Access Compliance Report Public Rights-of-Way (Curb Ramps)

Main Street: ARROYO_AVE Cross Street: MUMFORD_RD Location: SE

ADA ID: RPRK211013114805 Ramp Type: Type 1 - Perpendicular Diagonal Initial Pass/Fail: Pass Overall Compliance: No Severity Score: 45

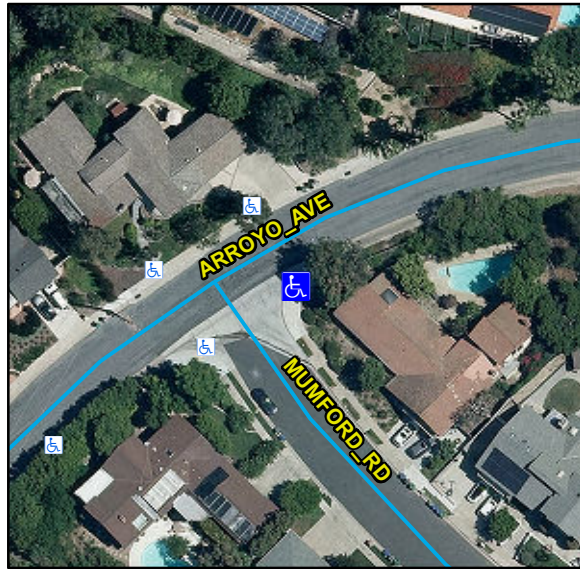
Compliance	Description	Data	Compliance	Description	Data
N/A	Ramp Length (in)	116	N/A	Flare Type LT	
Yes	Ramp Width (in)	48			Sloped
Yes	Ramp Run Slope (%)	7.7	No	Flare Slope LT (%)	15.8
No	Ramp Cross Slope (%)	10.3	N/A	Flare Traversable LT	Yes
N/A	Landing Present	Yes	N/A	Flare Type RT	
N/A	Landing Length (in)	50			Sloped
Yes	Landing Width (in)	48	N/A	Flare Slope RT (%)	9.8
Yes	Landing Run Slope (%)	1	N/A	Flare Traversable RT	No
No	Landing Cross Slope (%)	12.6	Yes	DWS Provided	Yes
N/A	Landing Movement Obstructed?	No	Yes	DWS Contrast	Yes
	Landing Movement Type	N/A	Yes	DWS Length (in)	36
N/A	Landing Shared	Yes	Yes	DWS Full Width	Yes
N/A	Clear Space	Yes	Yes	DWS Offset Left (in)	0
N/A	Clear Space To Crosswalk (in)	48	Yes	DWS Offset Right (in)	N/A
N/A	Marked Crosswalk 1	No	N/A	Marked Crosswalk 2	No
	Crossing 1 Direction	N		Crossing 2 Direction	W
	Marked Crosswalk 1 Width (in)	N/A		Marked Crosswalk 2 Width (in)	N/A

N/A	Ramp Inside Crosswalk 1	N/A	Yes	Ramp Inside Crosswalk 2	N/A
	Crossing 1 Slope (%)	5.7		Crossing 2 Slope (%)	0.9
	Crossing 1 Cross Slope (%)	12		Crossing 2 Cross Slope (%)	3.7
Yes	Gutter Ponding	No	No	Curb Slope	16.9
Yes	Gutter Lip Height (in)	0		Road Run Slope (%)	11.2
No	Gutter Run Slope (%)	11.6		Road Cross Slope (%)	7.4
No	Gutter Cross Slope (%)	5.7			
Yes	Overall Surface Condition: Acceptable		No	Perp Joint Present	No
	Cross Gutter Present?	Yes		Spandrel Present?	Yes
	Replace Cross Gutter?	No		Replace Spandrel?	No

Remove & Replace Curb Ramp With Two New Directional Ramps or Equivalent. Remove & Replace Gutter.
